Braidwood Station, Units 1 and 2
Facility Operating License Nos. NPF-72 and NPF-77
NRC Docket Nos. STN 50-456 and STN 50-457

Byron Station, Units 1 and 2
Facility Operating License Nos. NPF-37 and NPF-66
NRC Docket Nos. STN 50-454 and STN 50-455

Subject: Additional Information Supporting Request for License Amendment Regarding
Measurement Uncertainty Recapture Power Uprate

**Braidwood and Byron Stations
Measurement Uncertainty Recapture License Amendment Request (MUR LAR)
March 30, 2012**

Figure A3.1-1: Byron Station Typical
 Alden Test Laboratory Pipe Configuration

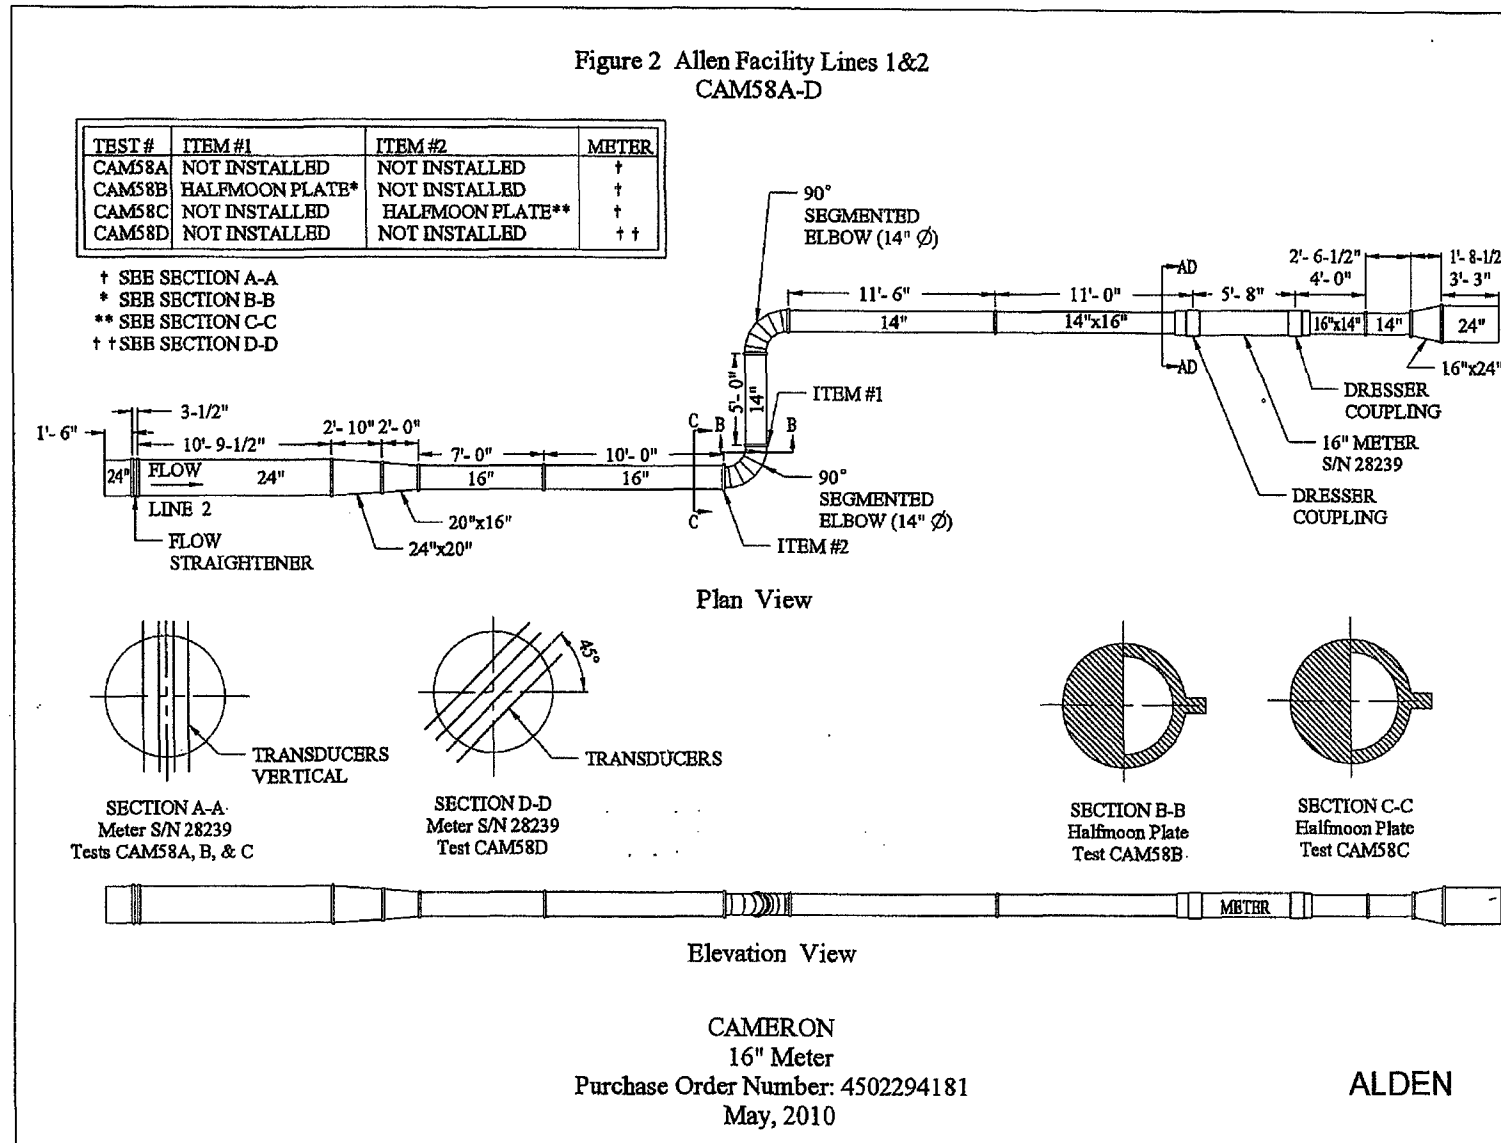
Test fidelity, such as test versus planned plant configuration, test variations to address configuration differences, and potential effects of operation on flow profile and calibration, should be addressed on a plant-specific basis. Applicant requests must provide a comparison of the test and plant piping configurations with an evaluation of the effect of any differences that could affect the UFM calibration. Further, sufficient variations in test configurations must be tested to establish that test-to-plant differences have been bracketed in the determination of UFM calibration and uncertainty. The turbulent flow regimes that exist when the plant is near full power result in limited upstream flow profile perturbation from downstream piping. Consequently, the effects of downstream equipment need not be considered for normal CheckPlus operation provided changes in downstream piping, such as the entrance to an elbow, are located greater than two pipe diameters downstream of the chordal paths. However, if the CheckPlus is operated with one or more transducers out of service, the acceptable separation distance is likely a function of transducer to elbow orientation. In such cases, if separation distance is less than five pipe diameters, it should be addressed. Therefore the staff requests the licensee to provide downstream distances from the ultrasonic flow meter (UFM) to the next non-straight pipe component at the Alden labs test setup to verify their applicability to the in plant setup.

Figures A3.1-1 and A3.1-2 provide diagrams of the Alden Laboratory test piping configuration typical for Byron and Braidwood Stations, respectively. There were no downstream elbows included in the test configuration. Attachment 11 of the Measurement Uncertainty Recapture (MUR) License Amendment Request (LAR) (Reference A3-1) provided the typical in-plant piping configuration; the closest elbow is greater than five pipe diameters (approximately 30-feet) downstream of the LEFM spool piece.

Figure A3.2-1: Byron Unit 1 Feedwater Flow - Venturi Flow Minus LEFM Flow (per Loop)

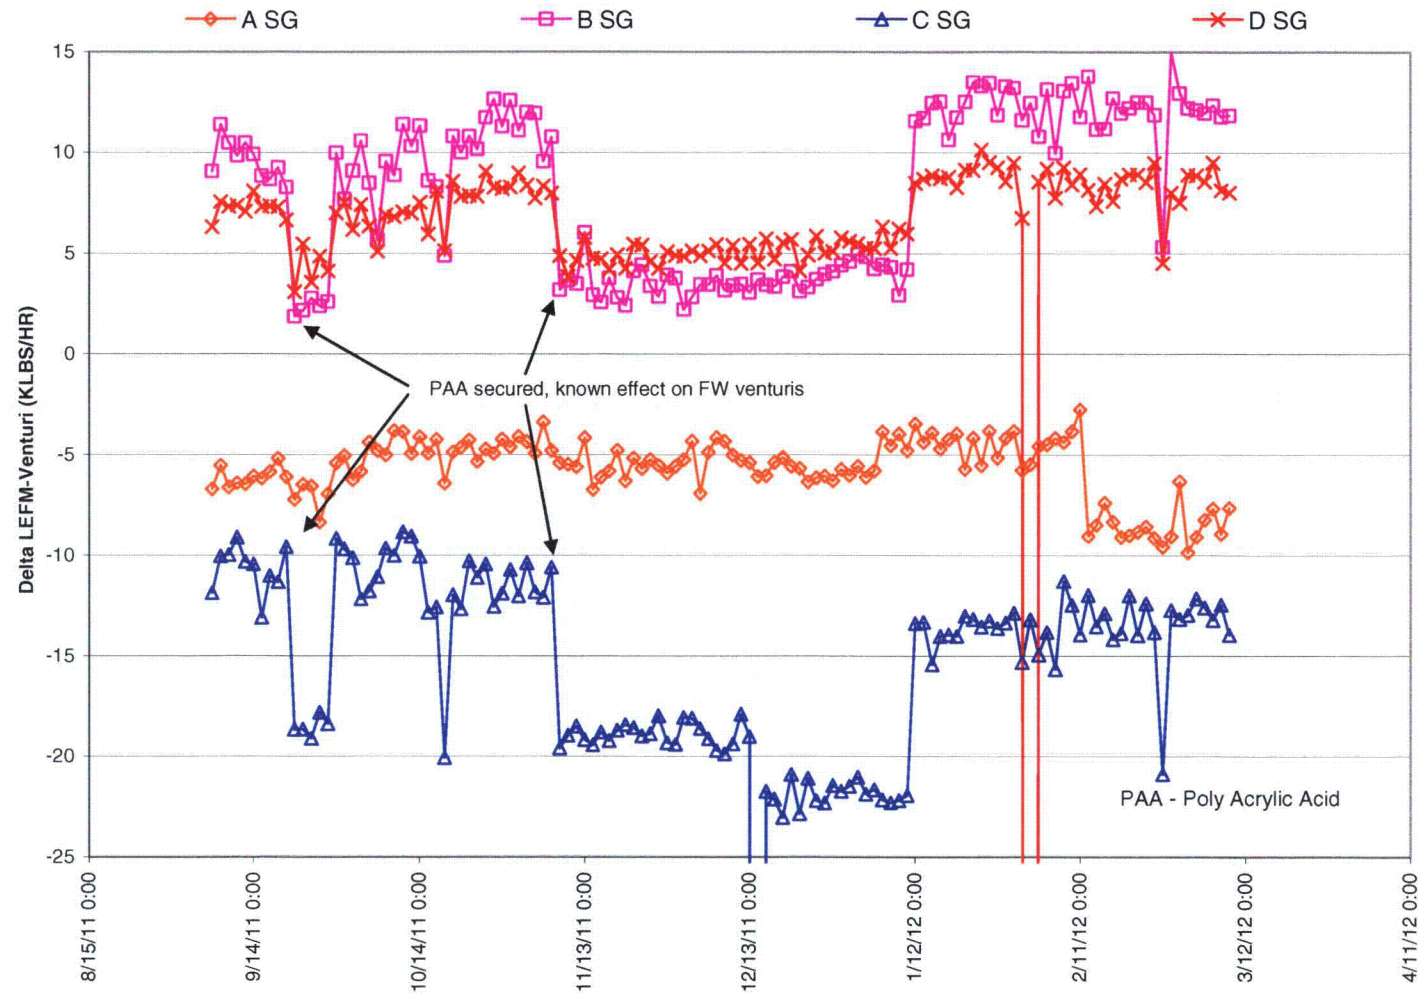
Each applicant for a power uprate must conduct an in-depth evaluation of the UFM following installation at its plant that includes consideration of any differences between the test and inplant results and must prepare a report that describes the results of the evaluation. This should address such items as calibration traceability, potential loss of calibration, cross-checks with other plant parameters during operation to ensure consistency between thermal power calculation based upon the LEFM and other plant parameters, and final commissioning testing. The process should be described in written documentation and a final commissioning test report should be available for NRC inspection. Therefore the NRC staff requests the licensee to provide a summary of the data comparing the LEFM Checkplus operating data to the Venturi data for the past 6 months to verify consistency between thermal power calculation based on LEFM and other plant parameters.

The data provided is derived by taking flow data and averaging over a two hour period. One two hour average is collected every 36 hours and reported in the files on the accompanying CD and graphed on Figures A3.2-1 through 6. Figures A3.2-1, 3 and 5 show the difference between the venturi and the LEFM flows for each of the feedwater line flows for Byron Units 1 and 2, and Braidwood Unit 2, respectively. Figures A3.2-2, 4 and 6 show a comparison of the total feedwater flow between the venturis and LEFM for Byron Units 1 and 2, and Braidwood Unit 2, respectively.
